Blanket Expanded Repair Approval Requisition

**The following TR blade is being submitted
for a blanket repair approval**

RBI # - 125A

COMPANY:	Bell Helicopter TEXTRON	DATE:	February 9, 2004
ATTENTION:	Rotor Design Engineering	REFERENCE:	Attached Repair Request
SUBJECT:	Expanded Main Rotor Component Field Repair Request	COPY:	BHTC Airworthiness

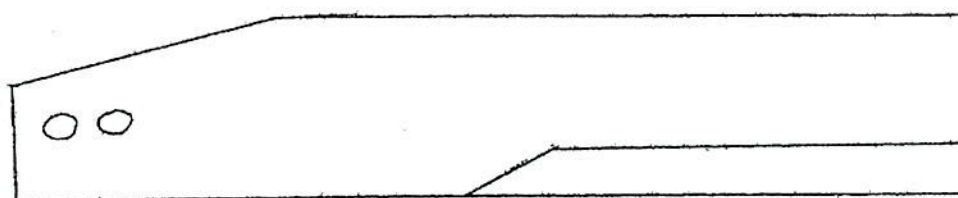
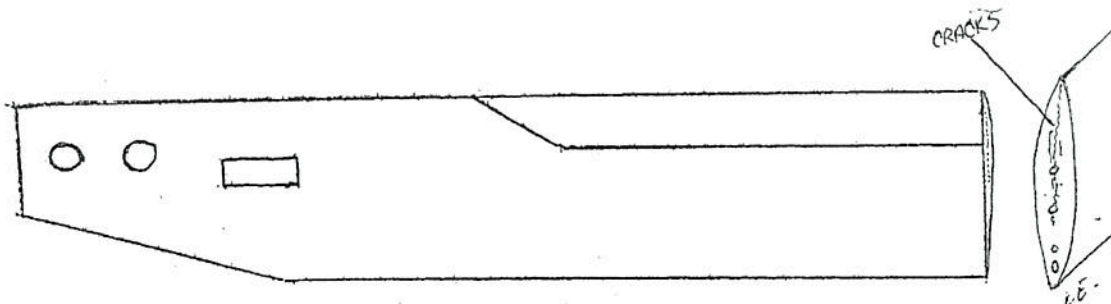
Discrepancy: **Tip block Cracked.** Crack is extending from tip weight screw hole. Possibly caused during tip weight installation or removal operations.

Please See Attached Sketch

Corrective Action: Tip Block Replacement

- 1.) Using a Dremmel tool or suitable cutter. Remove damaged tip block from blade. Do not damage blade skin.
- 2.) Clean blade thoroughly and prepare blade and block for bond with dry grit blast per BPS 4352 .

- 3.) Place a one inch strip of supported adhesive around the nose of the tip block, then cover the entire bonding surface of the tip block with adhesive using AF163-2K. An additional layer of unsupported is acceptable to fill variations in fit.

- 4.) Position the tip block in the blade per B/P and install blade in bonding tool. Bond tool shall consist of clamps, pressure plates and heating elements as required to provide uniform bond line pressure (14 psi min), and contour control. Heat bond line to 230° F and cure for 2 hours. On excess portion of tip block, prepare and bond a fiberglass test strip in conjunction with tip block.

- 5.) Allow to cool to 130° F and remove blade from tooling
- 6.) Inspect bond by tapping, **NO VOIDS ALLOWED.** Peel fiberglass test strip from excess and inspect for cohesive bond failure. Any indication of improper bonding shall be cause for tip removal and rework.

- 7.) Apply a tension proof load of 1320 lbs to the excess portion of the tip block. The root end should be restrained using a 406-012-102 Yoke and NAS6606 bolts or equivalent. After completion of the proof load test, inspect the tip for signs of disbonding. Any indications will be cause for block replacement

- 8.) Cut away excess tip block. Finish tip profile by sanding with 220 grit
- 9.) Refinish and Balance as required. Refinish per BPS 4488 and balance to master T/R blade.

- 10.) Tooling must be adequate to maintain blade twist and contour
- 11.) Use tip block P/N 406-016-110-103
